APPLICATION NO.	FILING DATE	FIRST NAMED INVENTOR	ATTORNEY DOCKET NO.	CONFIRMATION NO.
10/596,437	06/13/2006	Carlo Vaccari	58009-021600/US	6689
33717 7590 09/04/2008 GREENBERG TRAURIG LLP (LA) 2450 COLORADO AVENUE, SUITE 400E INTELLECTUAL PROPERTY DEPARTMENT			EXAMINER	
			NGUYEN, TRINH T	
	SANTA MONICA, CA 90404		ART UNIT	PAPER NUMBER
			3644	
			MAIL DATE	DELIVERY MODE
			09/04/2008	PAPER

Application No.	Applicant(s)			
	10/596,437	VACCARI, CARLO			
Office Action Summary	Examiner	Art Unit			
	Trinh T. Nguyen	3644			
The MAILING DATE of this communication app Period for Reply	ears on the cover sheet with the c	orrespondence address			
A SHORTENED STATUTORY PERIOD FOR REPLY WHICHEVER IS LONGER, FROM THE MAILING DA - Extensions of time may be available under the provisions of 37 CFR 1.13 after SIX (6) MONTHS from the mailing date of this communication. - If NO period for reply is specified above, the maximum statutory period w - Failure to reply within the set or extended period for reply will, by statute, Any reply received by the Office later than three months after the mailing earned patent term adjustment. See 37 CFR 1.704(b).	ATE OF THIS COMMUNICATION 36(a). In no event, howeve

... UK Patent Application GB 2 207 331...A

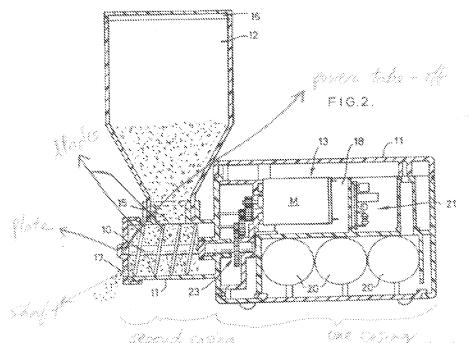
- (b) the invention was patented or described in a printed publication in this or a foreign country or in public use or on sale in this country, more than one year prior to the date of application for patent in the United States.
- 4. Claims 1,3,9,10 are rejected under 35 U.S.C. 102(b) as being anticipated by GB 2207331 (see attached Figure 2 at the end of this office action for further explanation).

For claim 1, GB 2207331 teaches a device for dispensing and distributing food for aquatic fauna, which can be fitted in aquariums or containers for holding live fish, as well as in tanks for turtles and terrariums in general or similar, this device comprising a tank (11) and means (23) for pushing the food towards a dispensing outlet, wherein the tank is positioned in a substantially horizontal direction and houses a pusher-mixer (10) which occupies the internal space of the tank and consists of a shaft equipped with a plurality of sloping blades all facing in the same direction as the direction in which the food is pushed towards the dispensing outlet (17), whereby said dispensing outlet has a substantially vertical opening for the discharge of the food in a horizontal direction (see Figure 2).

For claim 3 (as best understood), GB 2207331 teaches wherein the plate of the shaft is functionally connected with the opening of the outlet and, depending on its

position, determined by the rotation of the shaft, allows or prevents food dispensing and prevents the entry of humidity rising from below (see Figure 2).

For claim 9 (as best understood), GB 2207331 teaches wherein the shaft is driven by an electric motor (13), housed in the casing, said motor rotating a kinematic drive unit (23) which drives a power take-off engaged on the end of the shaft opposite the end fitted with the plate (see Figure 2).

For claim 10 (as best understood), GB 2207331 teaches said power take-off (see Figure 2) is shaped so as to maintain a direct grip with the shaft, allowing control of the position of the mixer-dispenser, and thus of the plate (see Figure 2) according to the revolutions of the shaft determined by the drive unit (23).
